19 October 2020

Response to Council's Request for Further Information for DA0563/2019 in relation to Biodiversity Issues

As you are aware, Cumberland Ecology prepared a Biodiversity Development Assessment Report (BDAR), dated 10 October 2019, to accompany a Development Application (DA) for the proposed development of an eco-tourism resort (DA0563/2019) at 71 Fig Hill Lane, Dunmore, also known as Lot 3 DP 717776 (the 'subject property').

Figure 1. The subject land and the Biodiversity Values Map

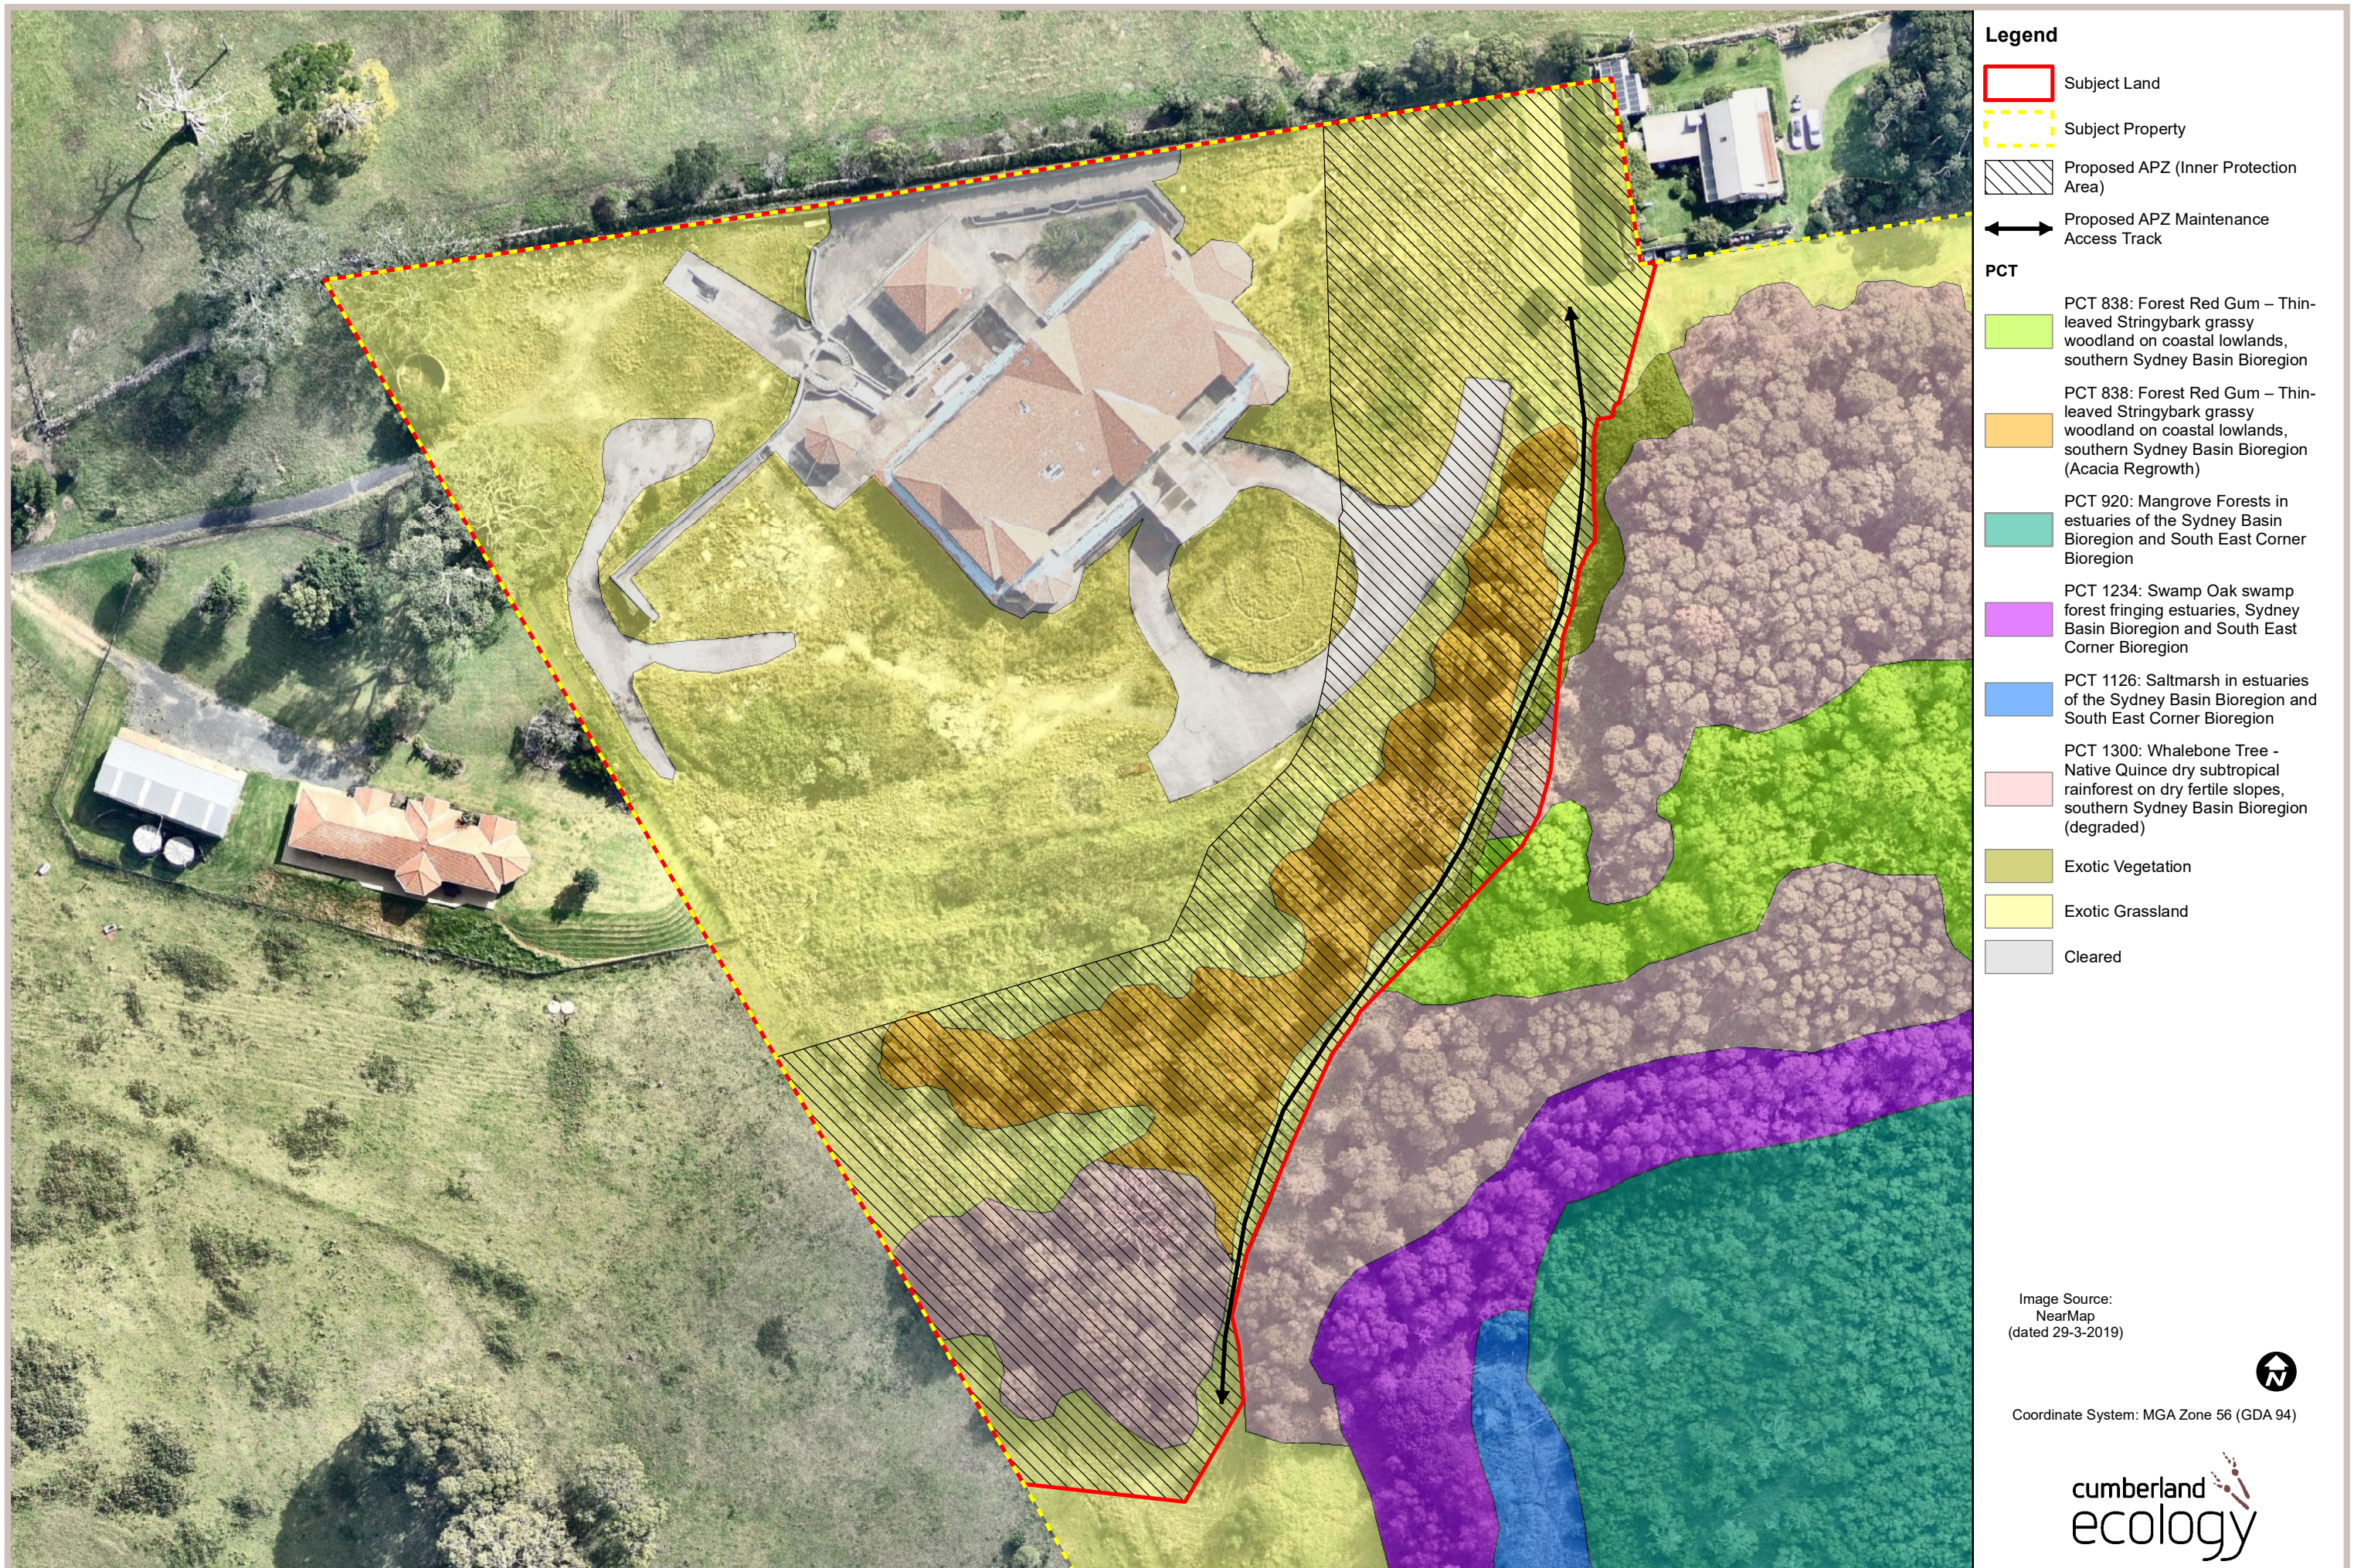
(a) The BDAR has not addressed the Biodiversity Values Map (BV Map). Please provide an overlay of the BV Map and the development footprint in the BDAR

A map of the BV Map in relation to the subject land (development footprint) has been provided in **Figure 1** of this letter. No areas mapped on the BV Map occurs within the subject land. Nevertheless, a BDAR was still prepared for the DA as a precautionary approach, due to the proximity of the proposed development to the Coastal Wetland mapped under the Coastal Management SEPP and TECs.

Figure 2. Proposed Asset Protection Zones (APZ) in relation to PCT mapping

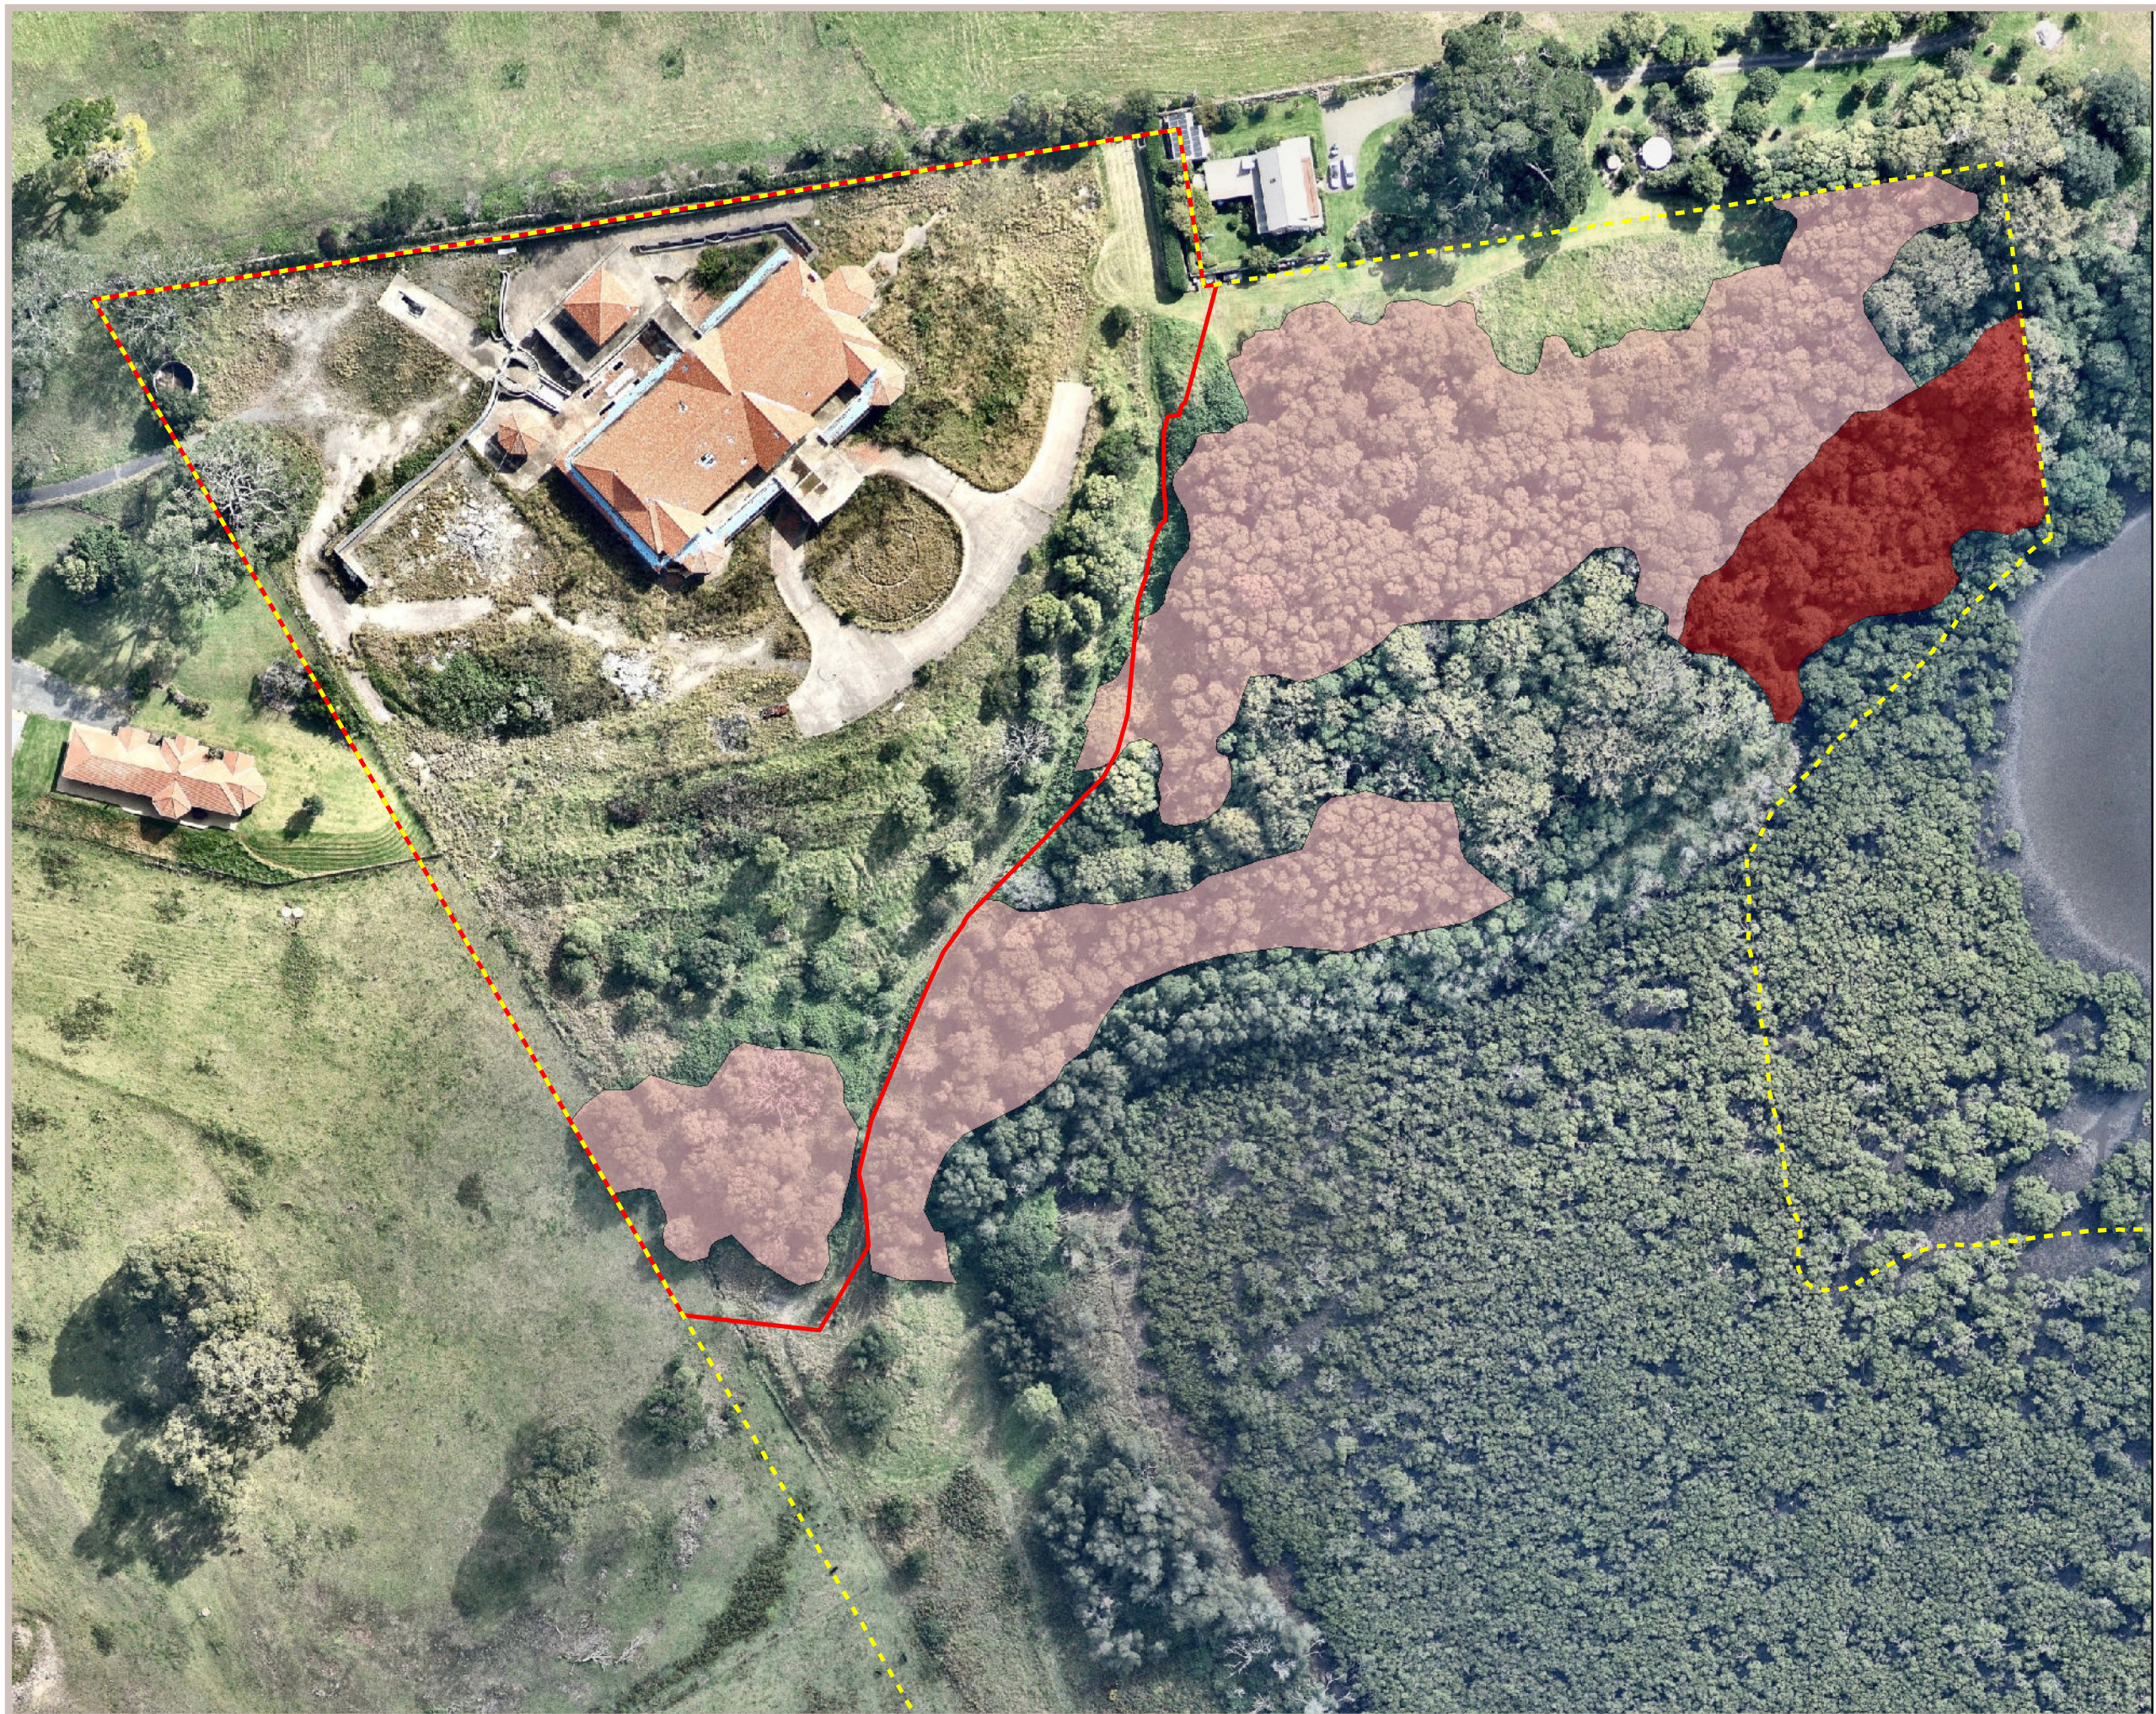
(b) Please provide a map overlay of the Inner and Outer Protection APZ's, location of Fire Trails and their clearing and maintenance requirements in the BDAR

(d) Figure 15 – Plan of Asset Protection Zones within the Australian Bushfire Protection Planner Pty Ltd September 2019, Bushfire Protection Assessment, is to be overlayed with the vegetation layer within the BDAR to demonstrate that the clearing for APZ requirement is consistent with the BDAR, the overlay is to include Inner and Outer Protection Zones and the Maintenance Access Track

The location of the APZ, which will be managed as an IPA, and the location of the fire trail/maintenance access track is shown in **Figure 2**. The entire APZ is located within the subject land. The proposed maintenance access track overlaps with an existing cleared track along the eastern boundary of the subject land.

As outlined in the response to point 10 (b), the entire APZ will be managed as an IPA. The locations of the APZ and associated track are shown in **Figure 2**. The clearing for the APZ requirement is consistent with Figure 15 of the Bushfire Protection Assessment (ABPP 2019).
